STAFF REPORT

RZ/FDP 2001-MV-002

PROPOSAL: Rezone the subject site from R-1 to PDH-2 for the development of 43 single-family detached dwellings

WINSTEAD MANOR

CONCEPTUAL / FINAL DEVELOPMENT PLAN
ALTERNATE LAYOUT

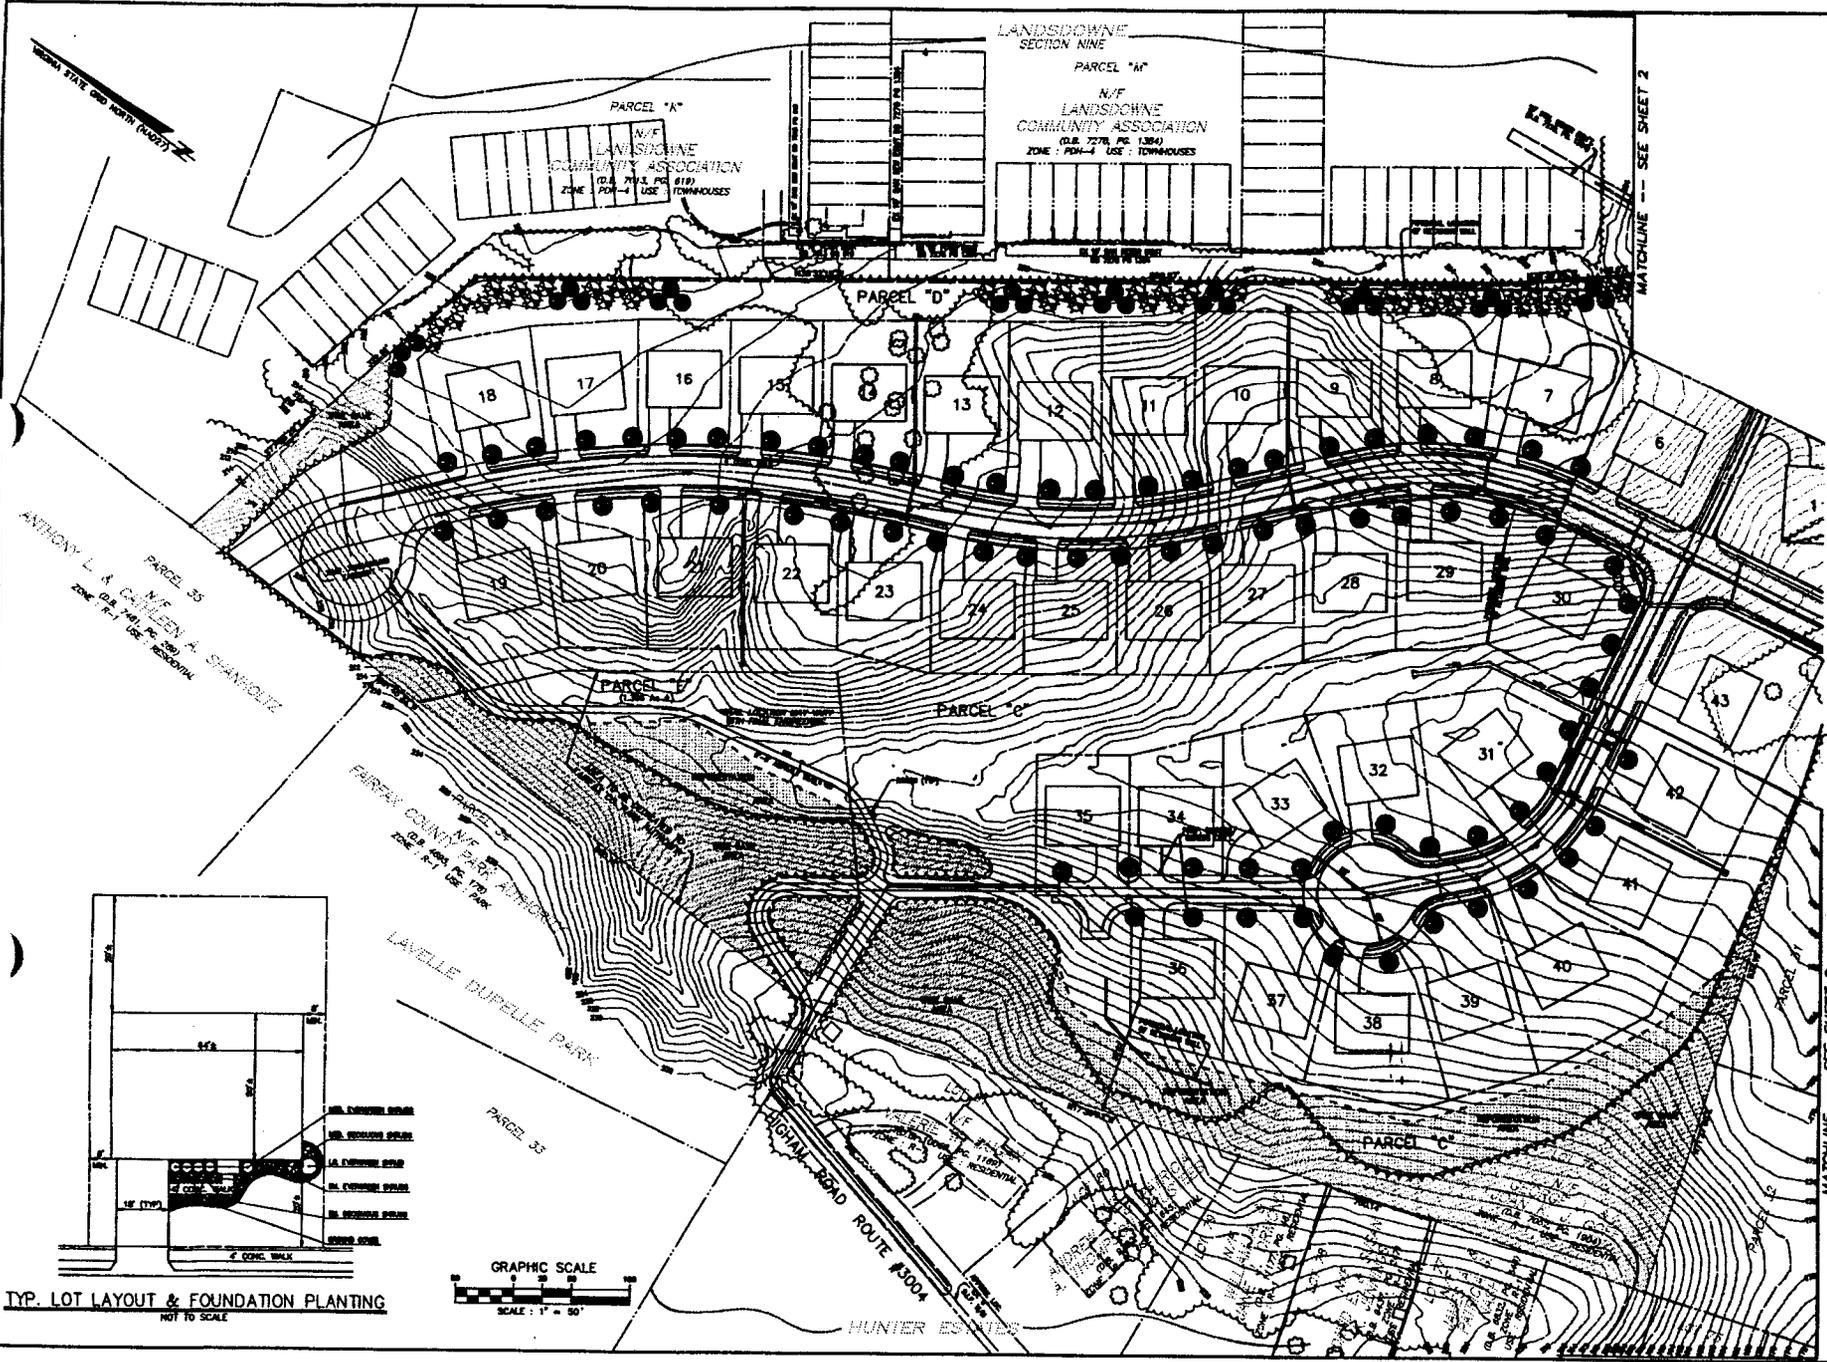
Tax Map Parcel 99-2 ((1)) 35, which is located to the north of the subject site, is currently developed with one single-family detached dwelling. It is planned for open space. Parcel 35 has no public street frontage. Currently, this lot is accessed from Higham Road across the Lavelle Dupelle Park. While this access may be adequate for one dwelling, it would not suffice should the parcel redevelop. As such, staff recommended that the applicant provide public street access for Parcel 35.

The applicant will be required to provide public street access for Parcel 35 at the time of subdivision approval. Proffer 2(k) notes that the applicant shall request a waiver of the requirement at the time of subdivision plan submission. Should this waiver not be granted, the applicant will construct interparcel access as shown on the CDP/FDP. Therefore, this issue is now resolved.

- k. Applicant shall request a waiver at time of subdivision plan submission of the requirement to provide interparcel access to the adjacent property identified among the Fairfax County tax map records as 99-2 ((1)) 35 ("Parcel 35"). Should waiver not be granted, Applicant shall provide access to Parcel 35 as shown on Sheet 3A of the CDP/FDP.
